# CITY OF ALBUQUERQUE

**Re: Advanced Auto Parts  
San Mateo & Claremont  
Traffic Circulation Layout**  
Engineer's/Architect's Stamp dated 8-7-15 (H17-D111)

Based upon the information provided in your submittal received 8-12-15, the above referenced plan cannot be approved for Building Permit until the following comments are addressed:

TCL SUBMITTAL  
**ADVANCE AUTO PARTS**  
SAN MATEO BOULEVARD AND CLAREMONT AVENUE  
**TRAFFIC CIRCULATION LAYOUT**

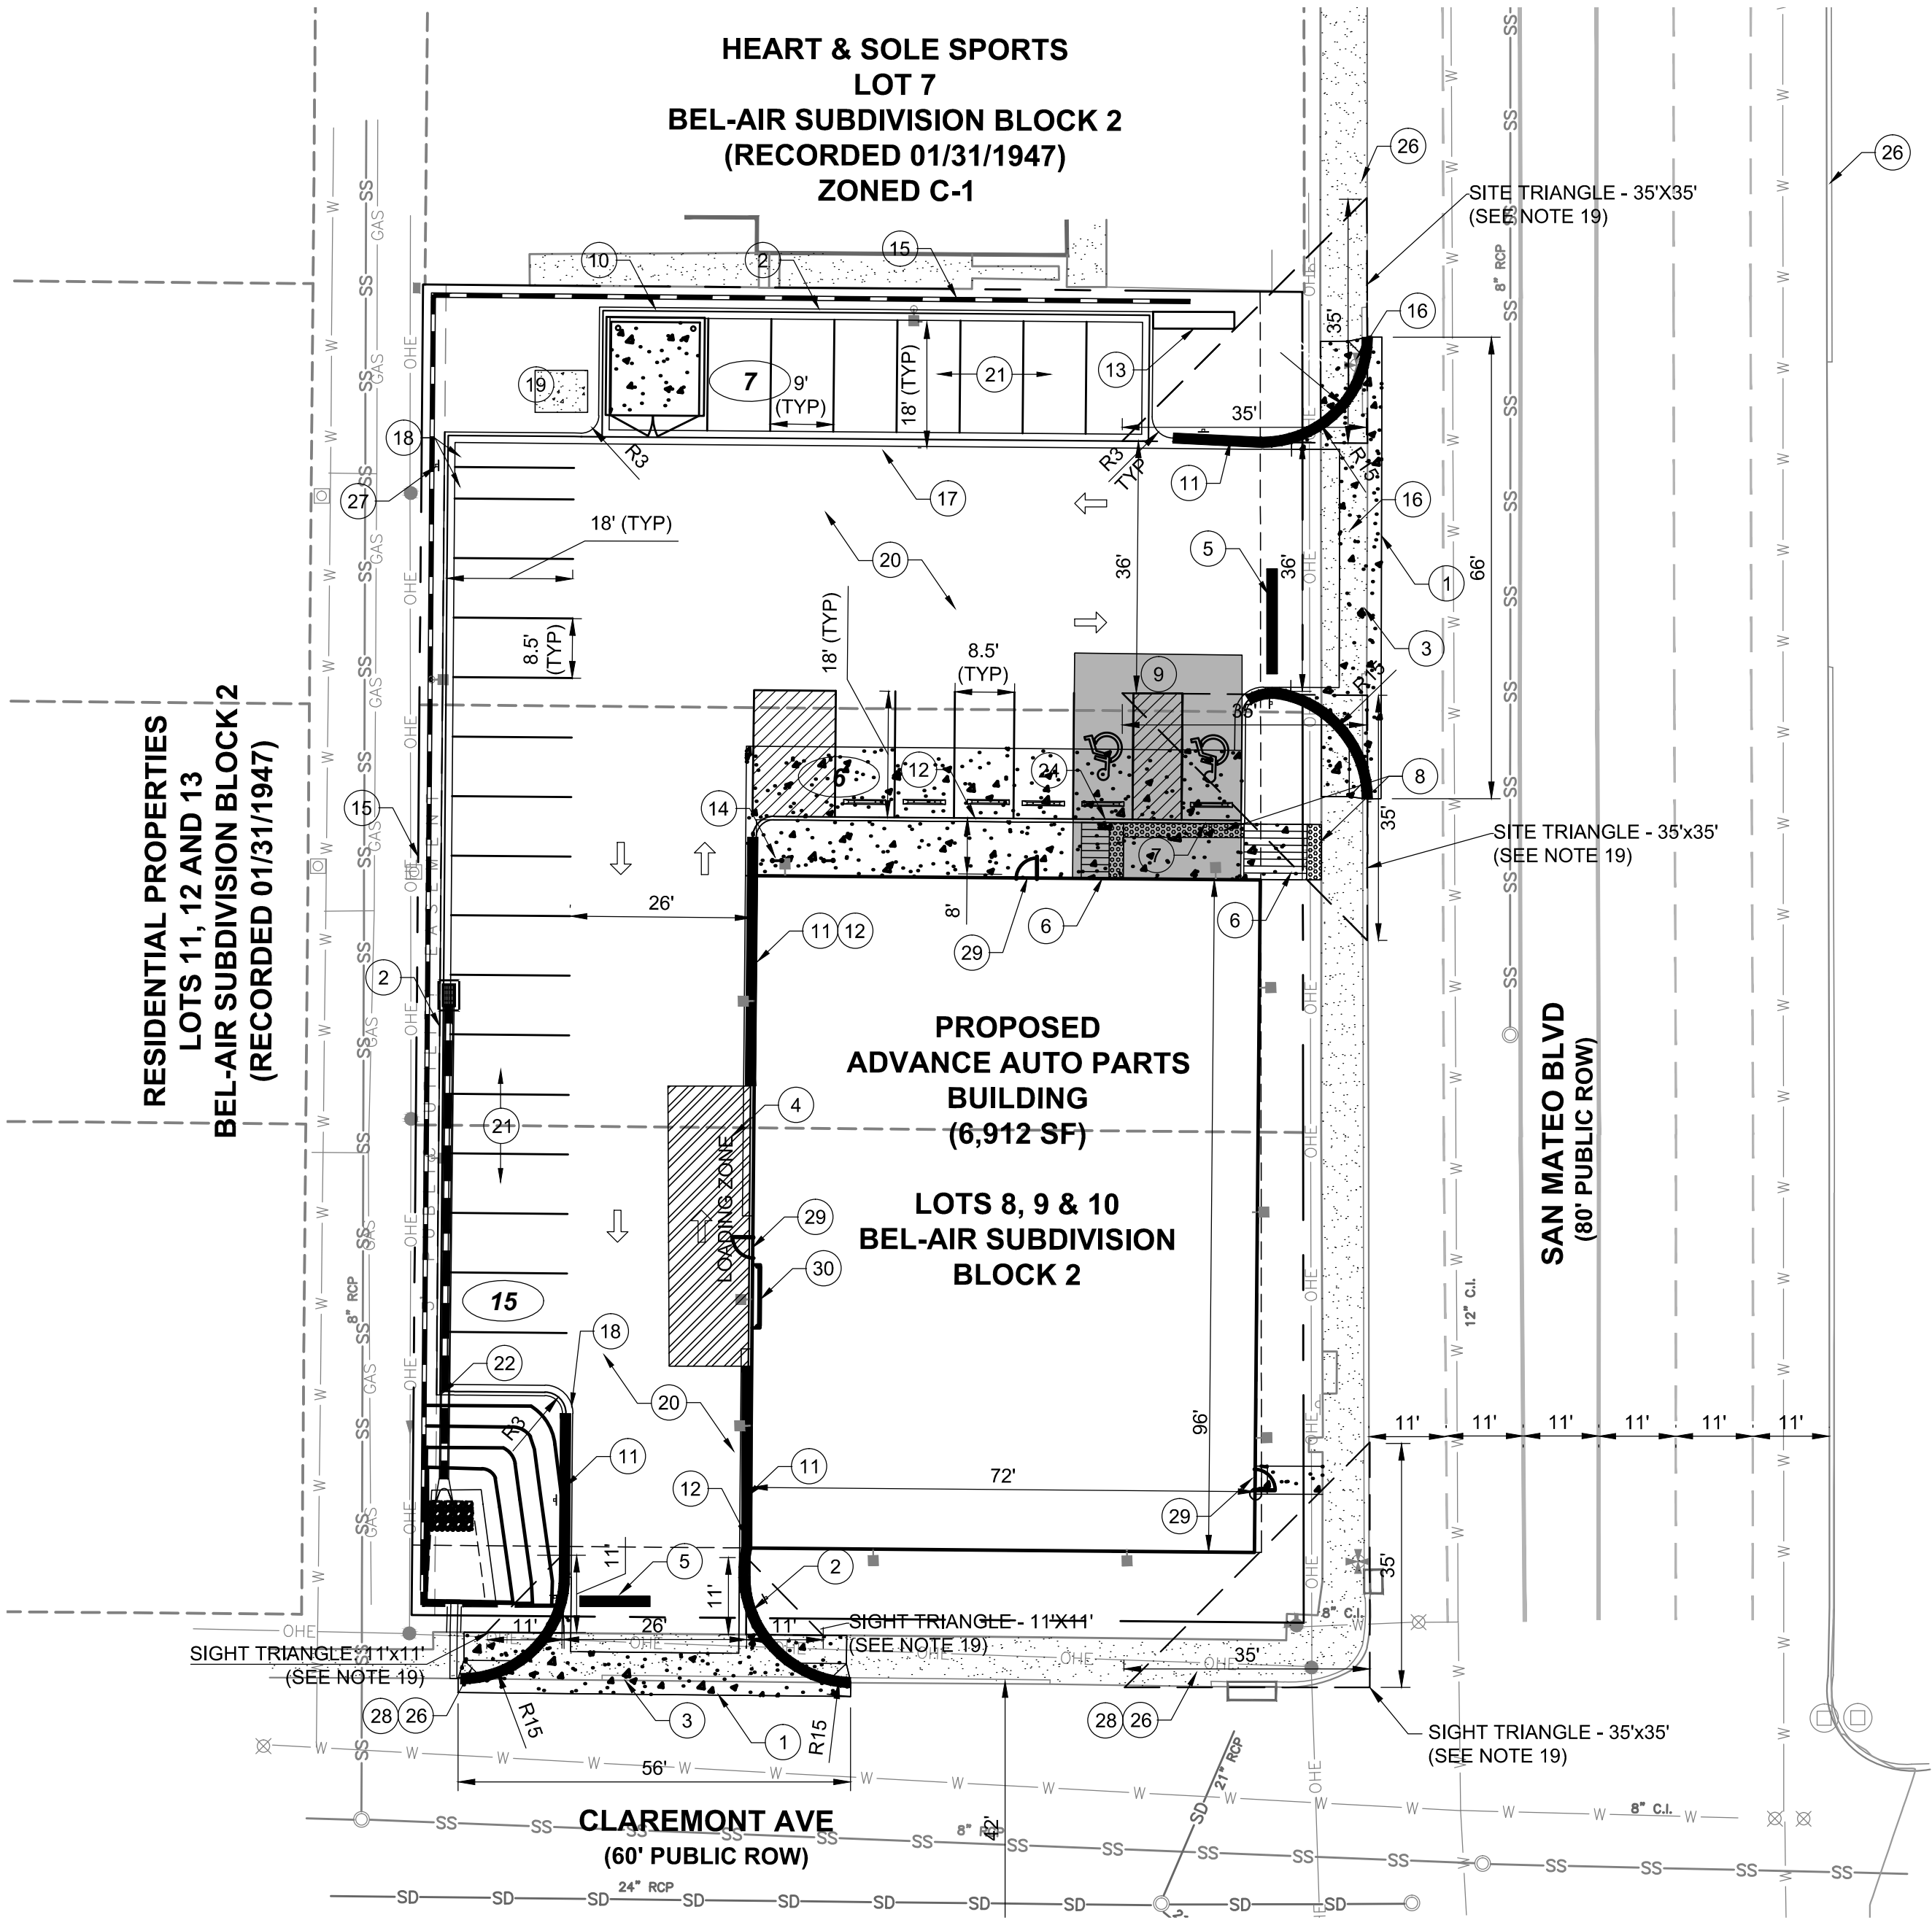
1. The handicap accessible spaces must be a minimum of 8.5 feet in width and 20 ft. in length. Per the submitted drawing, the proposed handicap parking space are 18 ft. long with a bumper car stop, which will yield at most a total length of 16 ft. length with a 2 ft. overhang. Please adjust the handicap parking space for a total of 20 ft. in length, while still retaining a minimal 6 ft. ADA pedestrian walk way.
2. Please include two copies of the traffic circulation layout at the next submittal.
